DEVELOPMENT APPLICATION ASSESSMENT REPORT

Application Number:	DA2021/2013
----------------------------	-------------

Responsible Officer:	Phil Lane
Land to be developed (Address):	Lot 41 DP 237862, 32 Badcoe Road CROMER NSW 2099
Proposed Development:	Alterations and additions to a dwelling house
Zoning:	Warringah LEP2011 - Land zoned R2 Low Density Residential
Development Permissible:	Yes
Existing Use Rights:	No
Consent Authority:	Northern Beaches Council
Land and Environment Court Action:	No
Owner:	Natasha Rachel Porteous Thomas Davis Kraus
Applicant:	Harriet Weir Design

Figure 1. Eastern Elevation

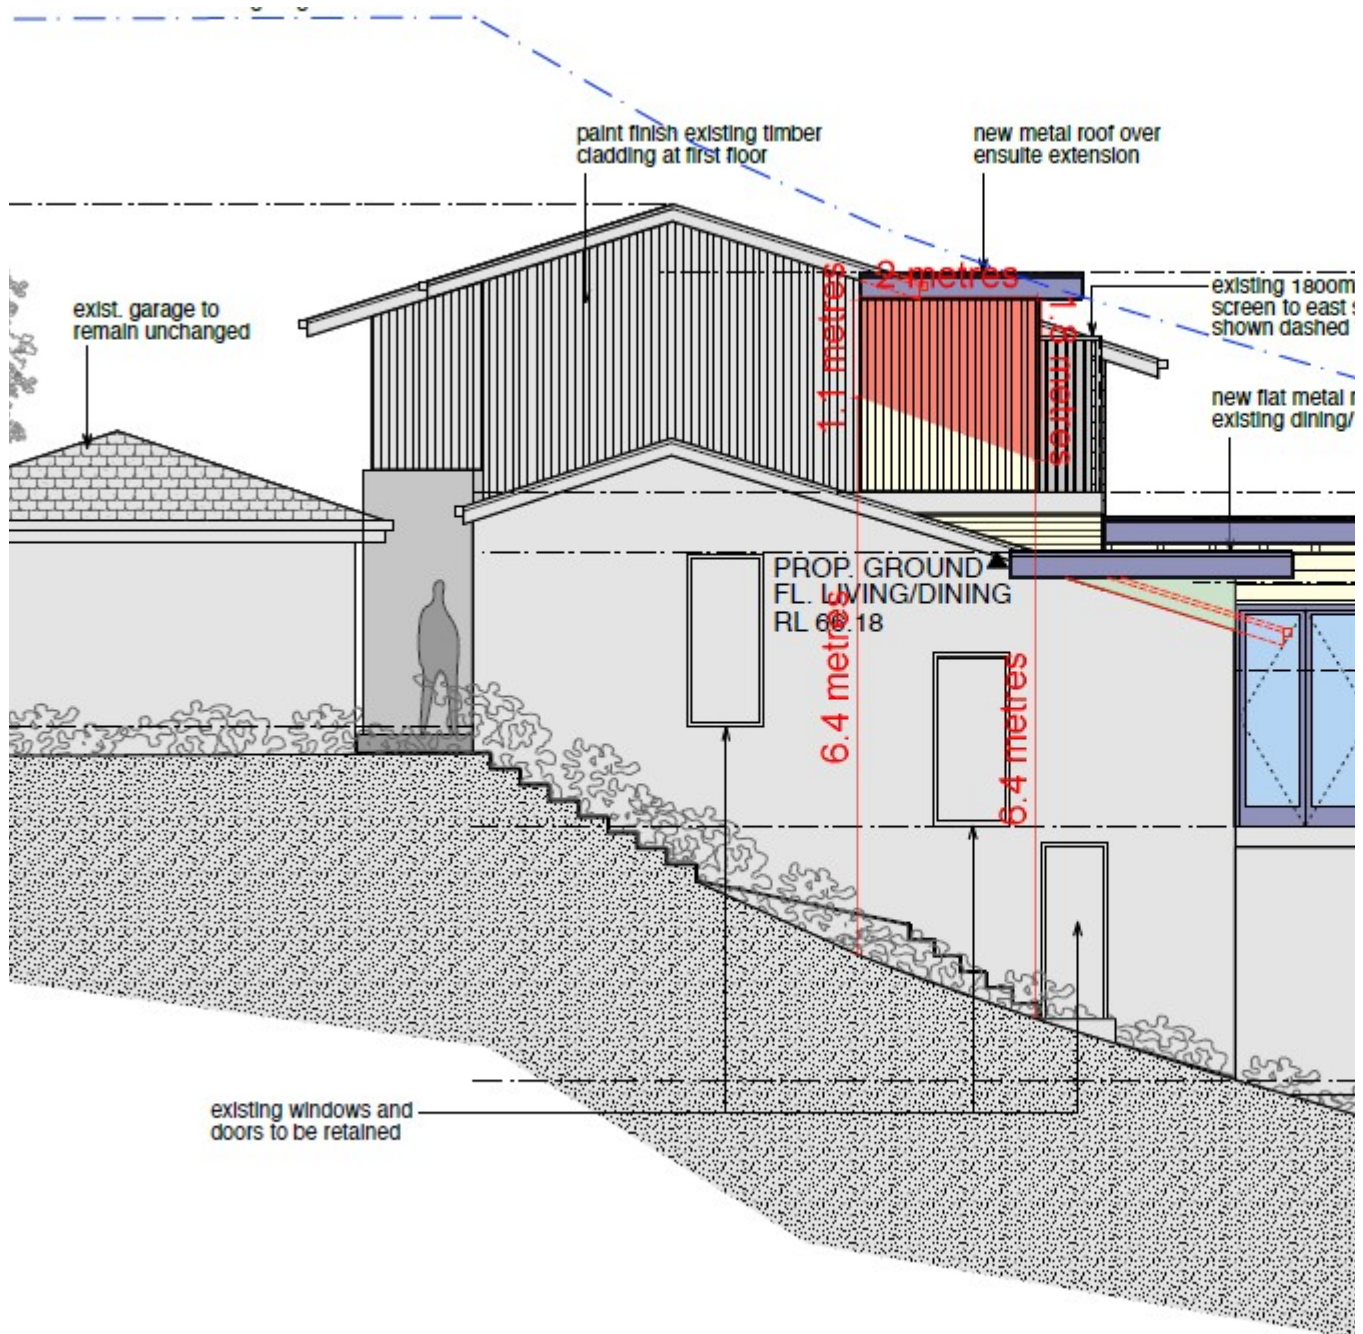
The proposal is sited outside of the building envelope along the eastern elevation as depicted in Figure 1. The eastern elevation encroaches outside of the building envelope for a maximum of 1.8m at the northern end and a minimum of 1.1m at the southern end for the horizontal length of only 2m, resulting in variations of 27.5% - 45%.

In this instance, the encroachment of the building envelope control is considered to be numerically non-compliant, however the proposal demonstrates compliance with the objectives of the control as outlined below. Therefore, the variation to the building envelope control is considered to be supportable.
